REMARKS

In the action of June 15, 2009, the examiner objected to the Specification, objected to the Drawings, rejected claims 1, 2, 6, 7 and 9-12 under 35 U.S.C. 102(e) as anticipated by Lev et al; and rejected claims 3-5 and 8 under 35 U.S.C. 103 as unpatentable over Lev in view of Moret et al. In a notice dated December 31, 2009, the previously submitted amendment to the specification was indicated to be improper.

REPLACEMENT SHEET

FIG. 11

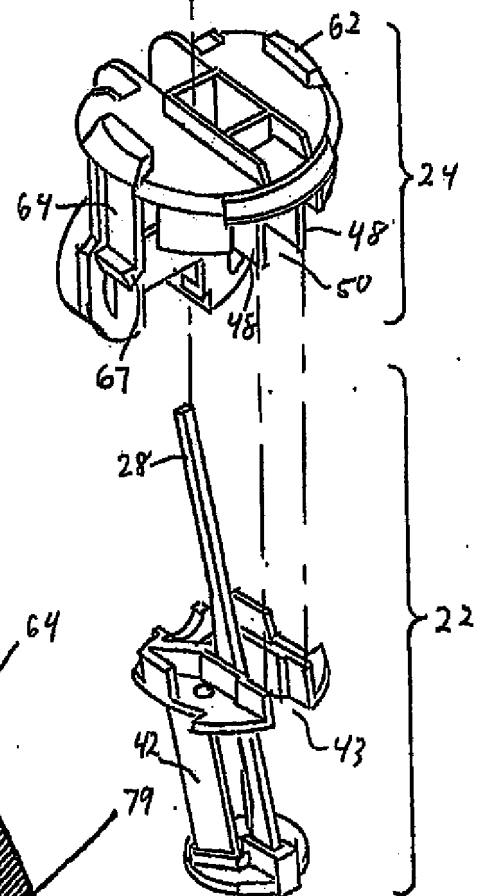
Applicant submits a revised sheet of drawings correcting the numeral 67 to 68 in Figures 11 and 12. This remedies the examiner's objections in both paragraphs 2 and 3 of the action. Approval of the amendment to the drawings is respectfully requested.
